AMENDMENT TO LEASE 5574.1  
GENERAL LEASE - INDUSTRIAL USE

Project Title: Chevron El Segundo Groin and County Outfall  
Extension

MITIGATION \*

\* Prepared in response to comments on the "Initial Study, El Segundo Marine Terminal (ESMT) Protection Project, El Segundo Refinery, For Chevron U.S.A., Inc.", by Dames and Moore, March 1, 1983.

FIGURE 1  
 FIELD SAMPLING PROGRAM  
 VIBRACORE LOCATIONS

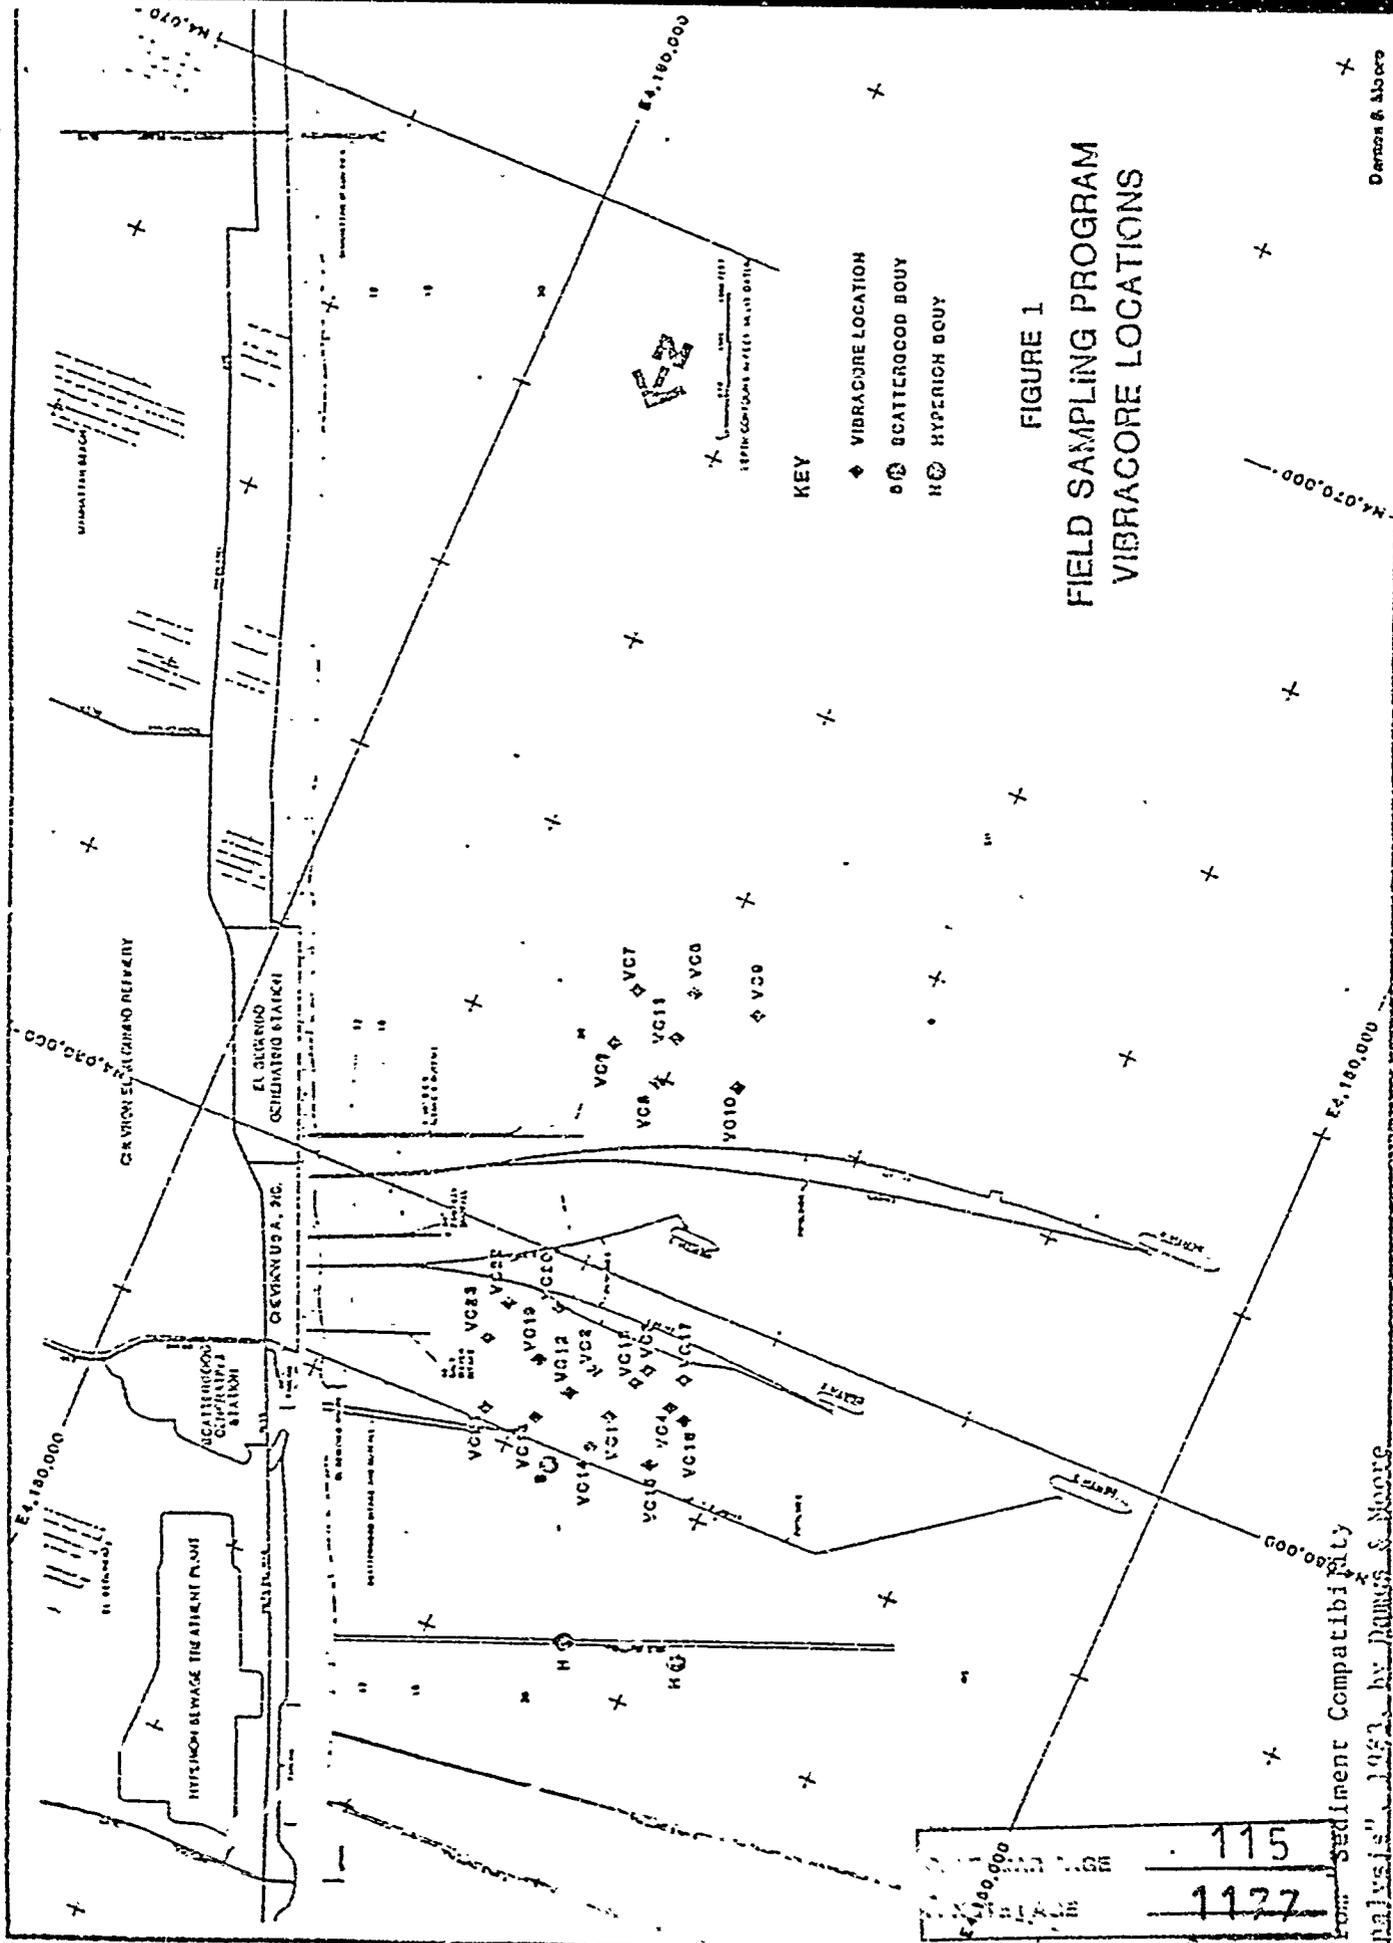
The question was raised of the compatibility of the borrow source material for the beachfill site. As mentioned previously, Dames and Moore made a sand compatibility study based on a program of 24 offshore core samples in December 1982 and January 1983. This report was submitted to the U.S. Army Corps of Engineers (COE) in March 1983. Following is a summary of the results of this report.

Figure 1 presents a drawing of an outline of the proposed borrow area with north-south and east-west cross-sections. This outlined surface area represents approximately 284,000 square yards. Sixteen vibracores between 3½ and 11 ft in length were obtained from this area. This number is in excess of the 11 vibracores required by the following formula presented in the COE guidelines:

(where N is the required maximum number of vibracores and A is the surface area of proposed dredging in square yards.)

FIGURE 2  
BEACH PROFILE  
MONITORING  
POINTS

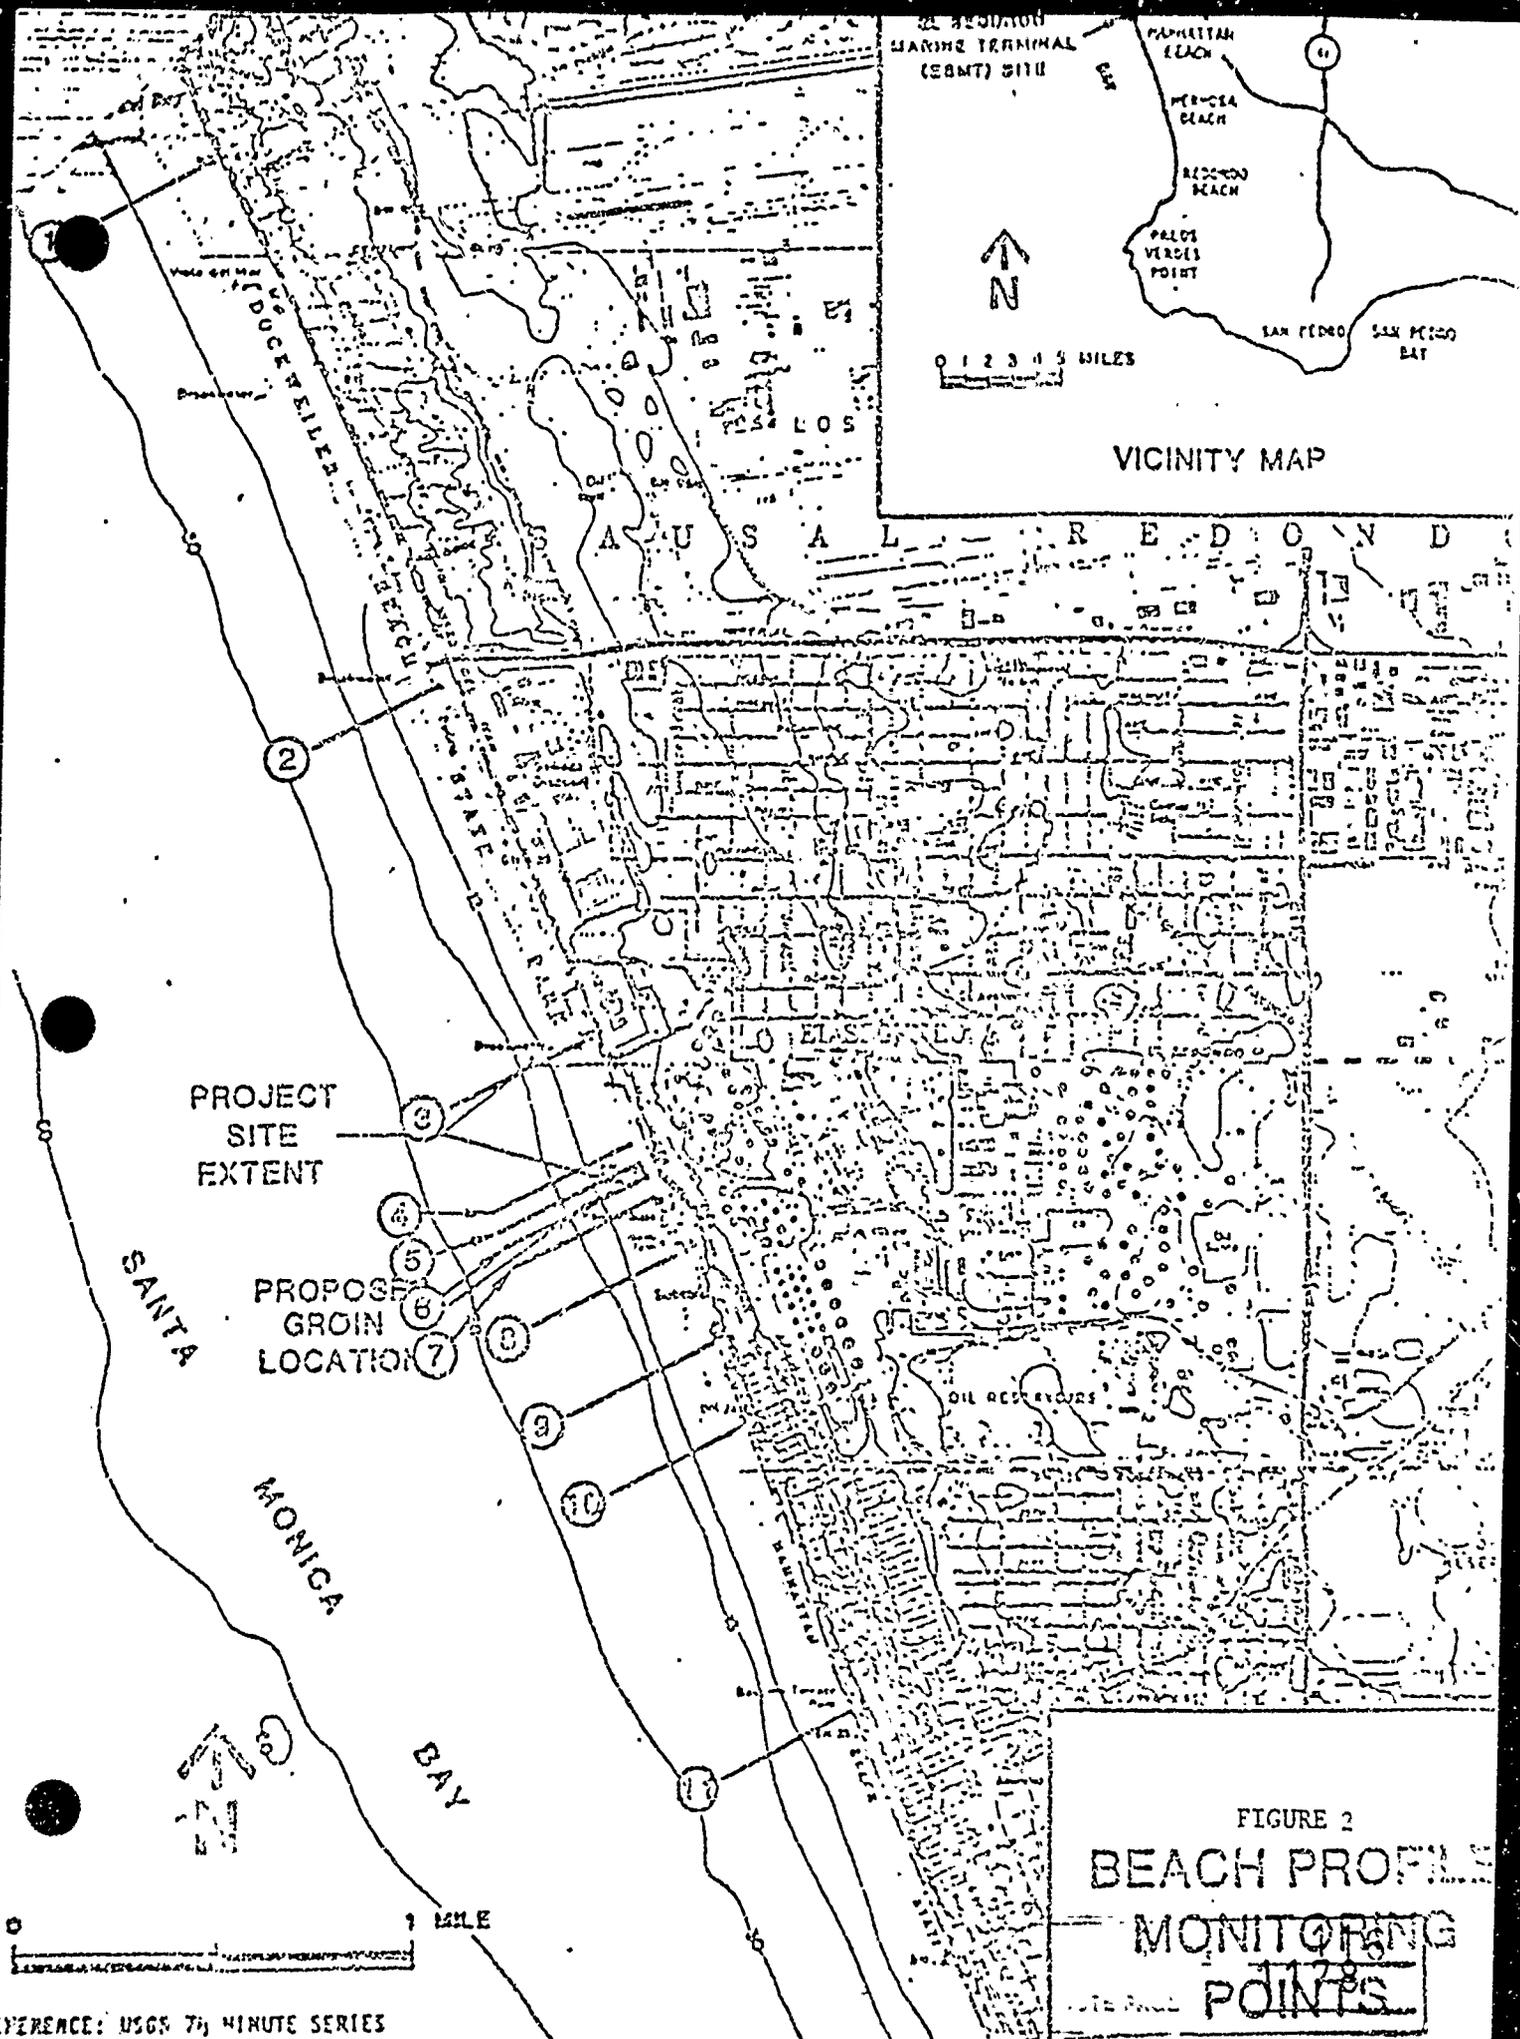
Chevron's primary design criteria has always been to avoid erosion on down coast beaches. Design alternatives which ignored this consideration were disregarded. Chevron's analysis of the design and sand pre-fill characteristics has been substantiated by third party experts in the field: Mr. John Hale, the designer of the proposed project, and Dr. Bernard Pipkin (See Appendix).

Chevron has developed a monitoring program which addresses down coast erosion and will detect any increase caused by the Chevron groin. The program is based on a survey of twelve (12) beach profiles from Playa Del Rey to Hermosa Beach (See Figure 2). These surveys will be taken semi-annually the years before and after construction and annually in August thereafter. This data will be analyzed by a third party consultant and a report prepared annually for at least five years. The analysis will consist of a determination of sand volume changes from year to year at depths from 0'MLLW to -25' MLLW. Changes will be compared between above groin profiles and below groin profiles. In the unlikely event that the consultant determines that a direct cause-effect relationship does exist between the presence of Chevron's groin and downcoast erosion, Chevron will take remedial action. Such action would have to be determined at the time, but could include beach nourishment, breach of a portion of the groin, a sand bypass system or repair of erosion-damaged property. The percentage of erosion attributed to the groin would establish the percent financed by Chevron. Chevron believes the design is sound, and that the annual analysis will substantiate this.

FIGURE 8: ESTIMATED OCEAN BOTTOM DEPTHS, A COMPARISON

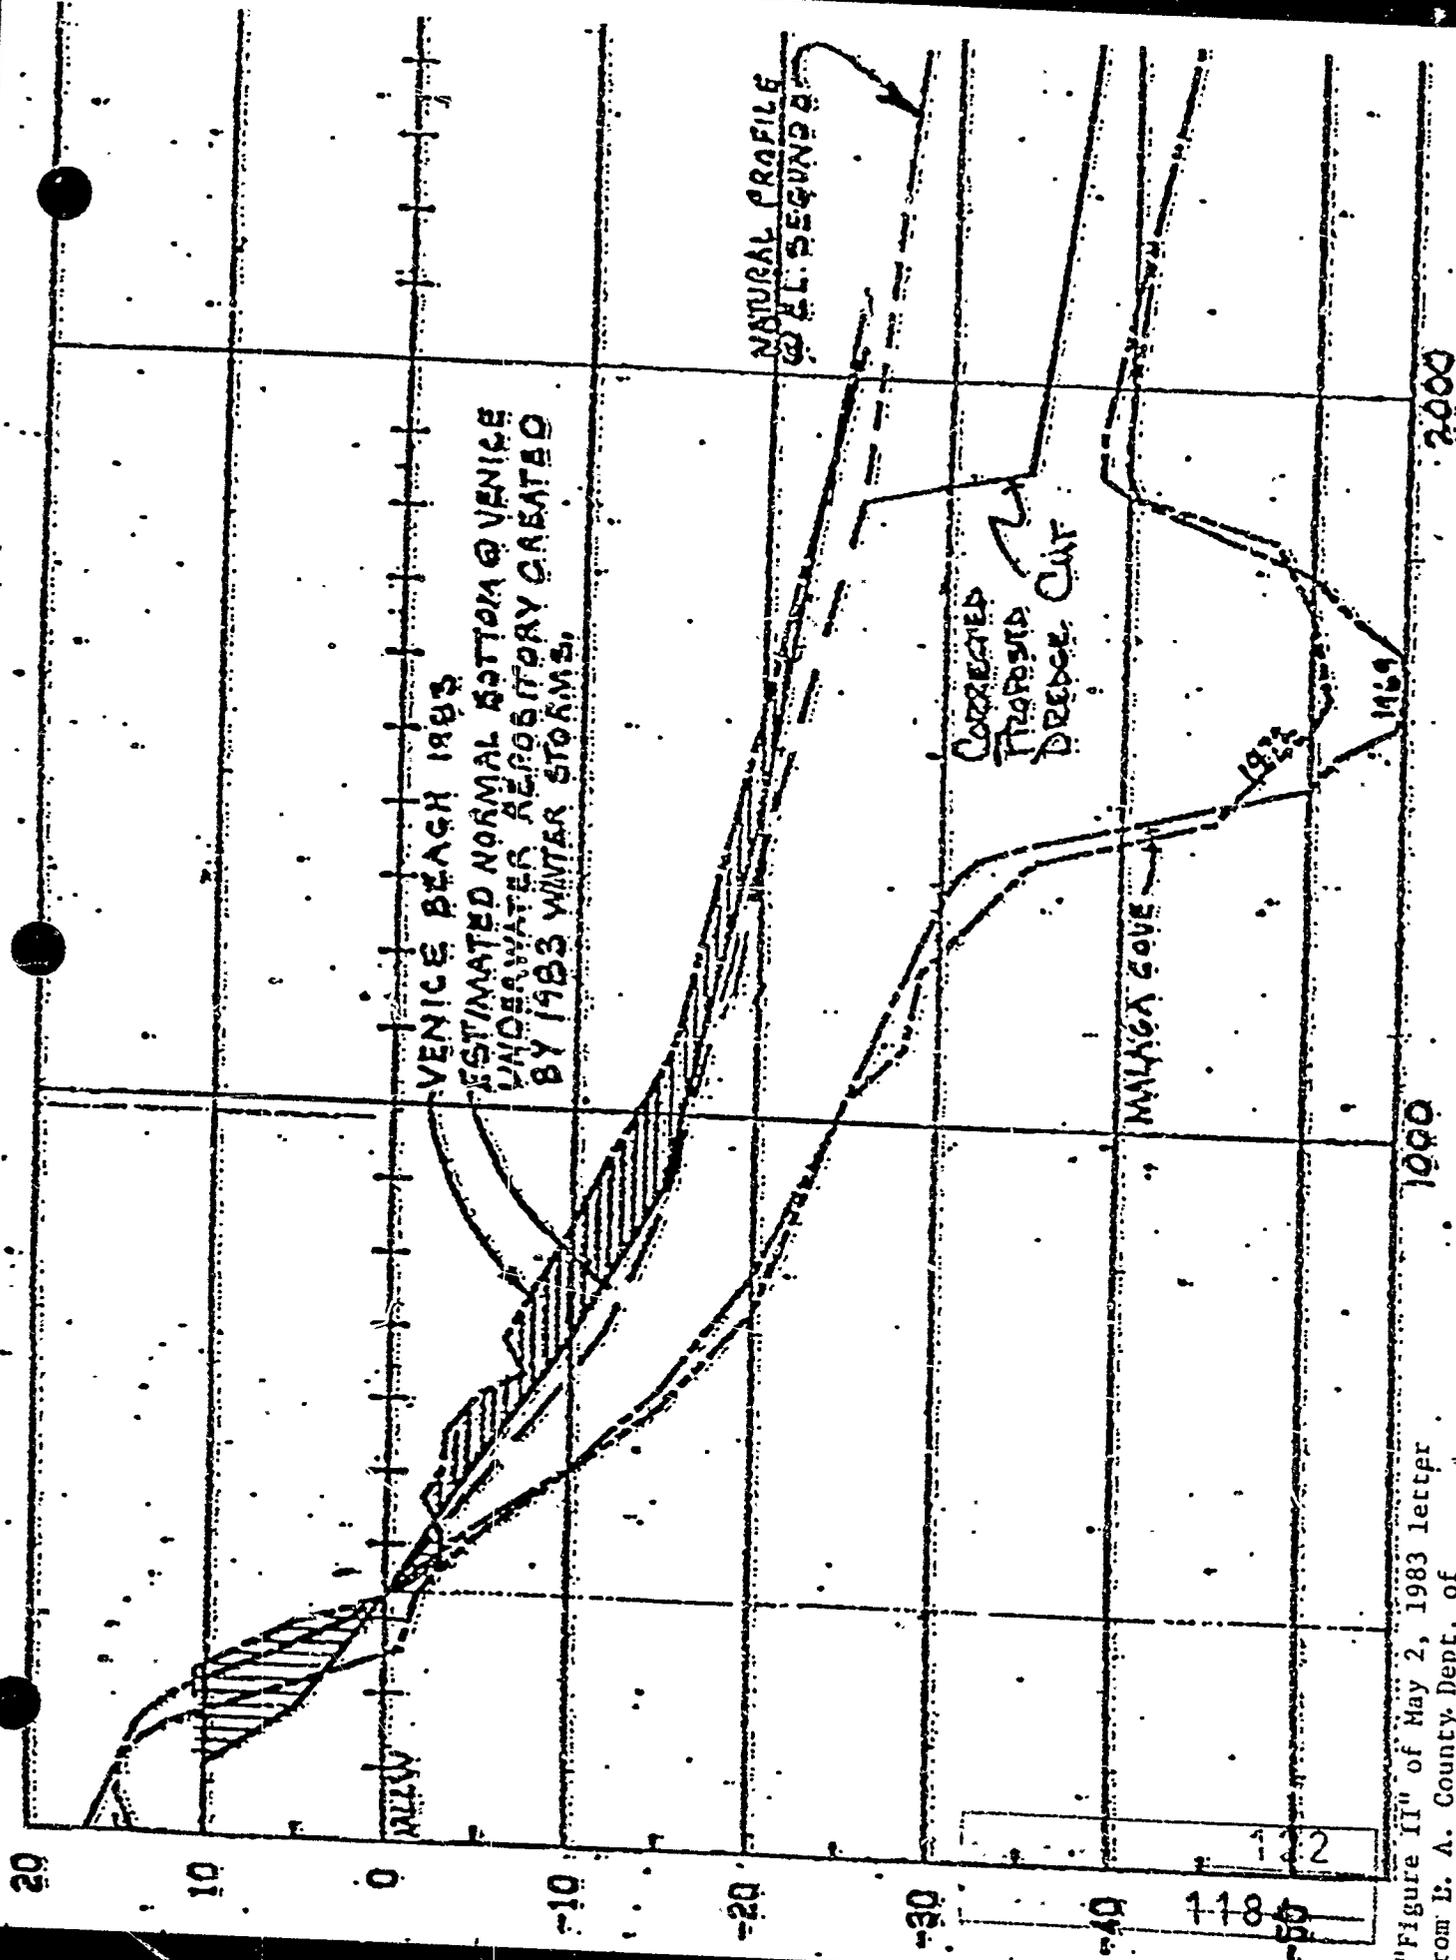
Concern has been expressed that the dredge borrow site is located too close to shore and will fill in with material drawn offshore from the beach fill. This would cause a deficit in sand carried in the longshore transport system, which would potentially result in increased down coast erosion. In support of this concern Los Angeles County Engineer - Facilities Department prepared several profiles depicting the Redondo-Malaga Cove dredge depression, the proposed El Segundo dredge depression and pre and post 1983 storm profiles near Venice beach (see Figure 8). In preparing the Figure, the County states that the Initial Study presents conflicting data on the inshore limit of the proposed dredge source. Since this data was used to formulate their conclusions, the following paragraph is presented to clarify the data.

The County's report refers to Page 64 of the Initial Study which indicates -25 ft MLLW at 1250 feet, while Figure 19 (from Initial Study) indicates -30 MLLW. The inshore limit of the proposed dredge cut is defined as -25 ft. MLLW. The length of the beach parallel dredge cut (north to south) is approximately 1,250 ft. This is not the distance from the shoreline (which presently is approximately 1,500 ft from the shoreline to the inshore limit of the dredge cut). The County selected Figure 19 from the Initial Study, to base their profiles of the proposed El Segundo dredge cut. Since this is a schematic drawing, scaling data from this figure is inappropriate. Chevron has have revised the County's Figure II (see Figure 8 of this report) to reflect a correct representation of the proposed dredge cut profile.

As shown on Figure II, a considerable amount of material has been drawn offshore Venice beach as a result of the 1982/1983 winter storms. The seaward limit of this storm includes offshore movement of material is shown in Figure 8 to be approximately -22 ft MLLW and only a small fraction (5 percent) of the total volume is seaward of -20 ft MLLW. Since the dredge cut will be seaward of -25 ft MLLW, there is little chance that any significant offshore transport of material will be drawn into the dredge depression by storm events and not returned to the active littoral zone. The profiles presented by the County for Venice beach are typical of profiles we have examined in Santa Monica Bay that all indicate the seaward limit of active on-offshore littoral movement is in the range of -17 to -22 ft MLLW. The shoreward limit of dredge cut was selected after examination of historical beach profiles, wave data and operational limits of available dredging equipment.
